Product hierarchy no. *			Part no.	SBU	Type / Description	Customer part no.
SBU / PG	PGU	Type				
02	007	060	0000002252	See list below	Strip Block	4752

2 Type of change

4752 Strip Block					0118.2240	
creation date	created by	release date	released by	notification no.	revision	page
2014-09-11	hotzar	2015-02-17	hotzar	27061	-	1 of 2

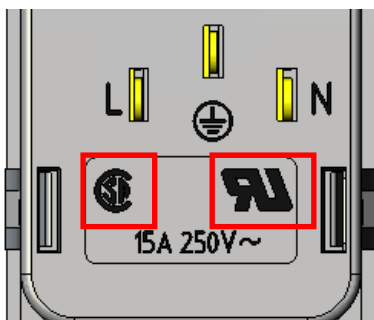
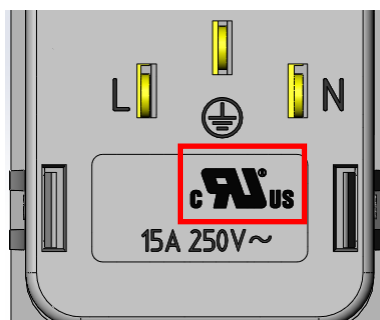
New combined cURus approval mark instead of separate UR and CSA marks.
Slight modification on the lateral indentation.

Old marking

New marking

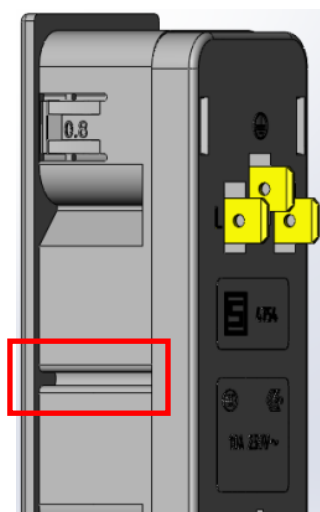
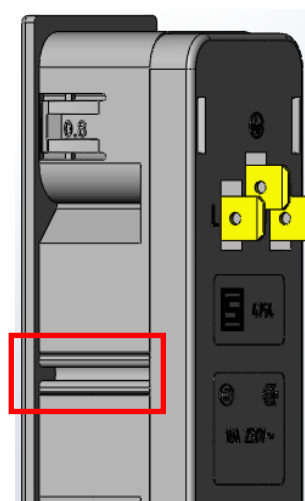
Modification of approval marks.
Slight modification on the lateral indentation.

Old form

New form

Consolidation of North American approval marks with the combined cURus mark.
Slight modification on the lateral indentation because of optimization of the injection process.
